DeKalb County Department of Planning & Sustainability

STAFF ANALYSIS

Case No.: CZ-20-1243853 **Agenda #:** N. 8

Request: A Major Modification of conditions of zoning pursuant to CZ-18-22125 for a mixed commercial, multifamily residential, and single-family residential development in an MU-5 (Mixed Use-5) district, to now increase the number of townhomes from 51 to 57 and reduce the number of single-family homes from 19 to 15.

2020 Site Plan

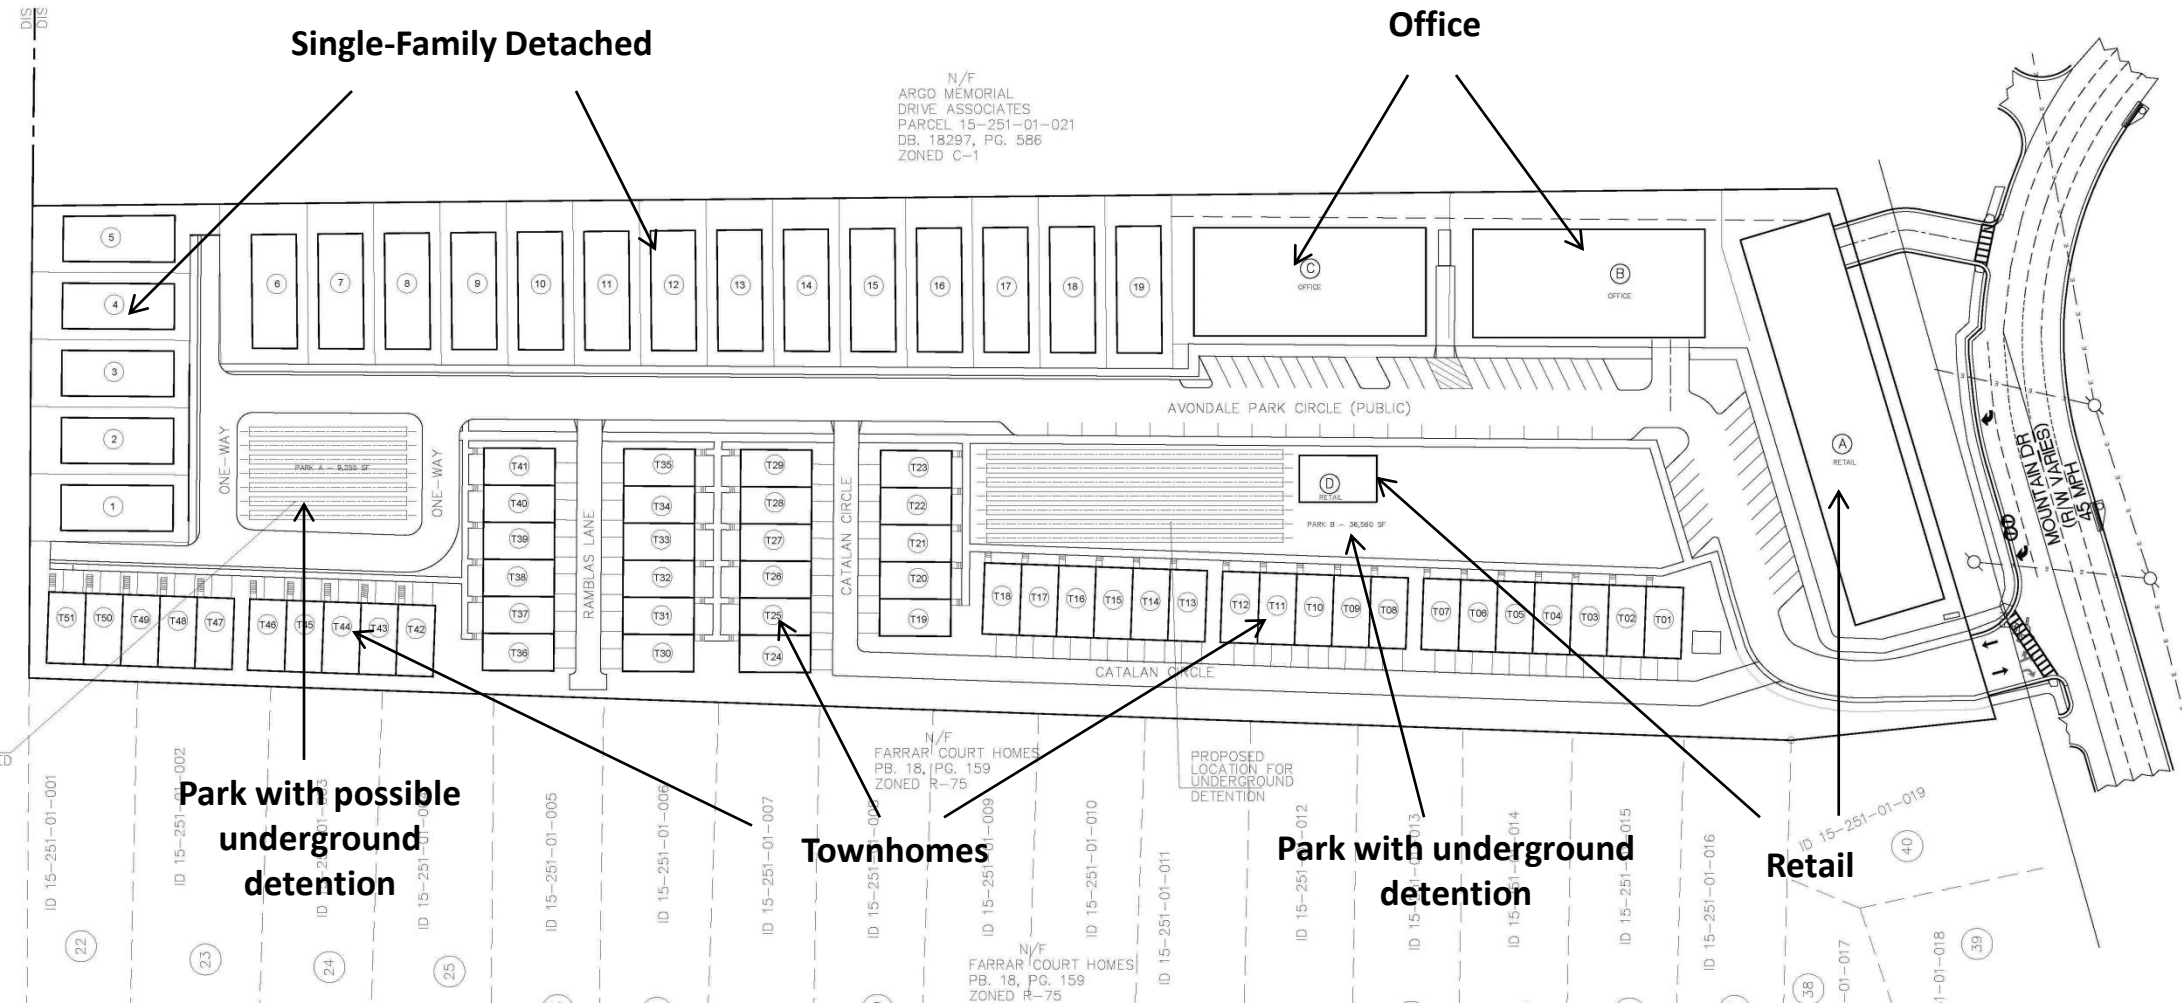
The townhomes are proposed to be a maximum of 35 feet high. The rear yards of several townhouse units along the western property line are located closer to the property line than the minimum of 50 feet required for the transitional buffer, and need to be screened with a combination evergreen landscape screen and opaque wall. In addition, because the rear yards of the single-family homes on the eastern side of the site will overlook the County Tax Commissioner’s office and parking lot, they should be screened to provide privacy to the residents of the homes.

Staff has advised the developer that if any of the buildings are more than 30 feet high, the International Fire Code requires adjoining streets to have a paved width of at least 26 feet. Because some of the streets and alleys are 16 and 24 feet wide, some modifications to the site plan might be necessary when the plan is reviewed by Fire Department staff for the land development permit.

1. The project site shall be developed in general conformity with the location of streets, land uses and buildings as shown on the site plan “Proposed Development at Avondale Park”, prepared by Proterra Development LLC, dated February 13, 2020. A buffer with a depth of 10 to 20 feet shall be provided between the proposed alley (“Catalan Circle”) of the proposed townhomes and the western property line (abutting the Farrar Court single-family subdivision) as shown on the aforementioned site plan. Existing trees within the transitional buffer shall be preserved and supplemented with new trees to form an effective visual screen as approved by the County Arborist. Invasive species such as bamboo may be removed from the buffer and additional plantings can be added to form a visual screen. Where invasive species are removed from the buffer, special consideration shall be given to prevent erosion and sedimentation during construction. A screen shall be installed along the entire length of the west property line and at the rear property lines of the single-family homes along the east property line, which shall consist of 1) an opaque fence with the finished side facing outwards and with a height of a minimum of six feet and 2) sufficient numbers of the following trees to provide a solid screen at maturity: arbor vitae, cryptomeria, or giant arbor vitae. The latter shall be added to existing trees to
